Product Change Notification

Date Issued :	July 31, 2026	PCN Number :	518533
Reason for Change :	Packaging Method/Quantity Change		
PCN Subcategory:	PCQC - DU Change		
Description of Change :	This notification is to inform you about part(s) listed in this notice that will undergo changes for new Delivery unit due to complete utilization of empty trays. No changes will be made to the product as a result of this change.		
Assessment of Change :	Drop Test		
Planned Implementation Date :	February 26, 2027		
Customer Sample Availability Date:	July 28, 2026		
Last date to request Samples by Customer : September 10, 2026			
Please note if Samples are not requested as per Customer Samples Request date, it may take additional 4-6 weeks to arrange Samples.

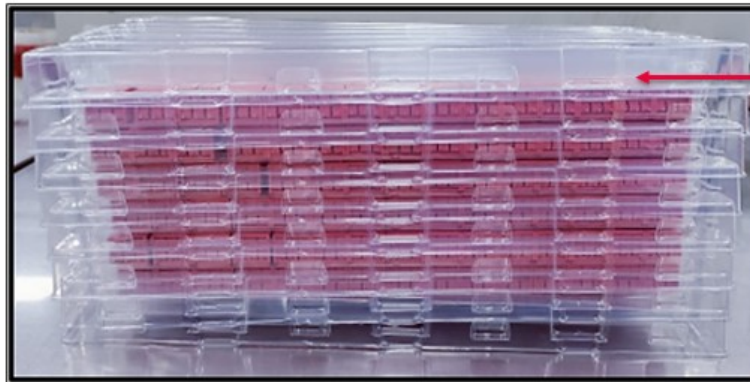
Observation from Tray Utilization – Refer to Image

- Only 6 Filled tray and one empty tray at Top was left unutilized.

- Under utilization of tray space as shown in below image
- Tube capacity not optimized

one empty tray at Top

- Tray packaging optimization - Evaluated the current packing method to ensure maximum utilization of tray packaging.
- **All 7 trays are filled and additional closure at top as shown in image below.**
- No change in packaging method, all packaging materials remains the same.
- DU needs to be change as provided in new quantity template provided along with this PCN to fill all the tray.
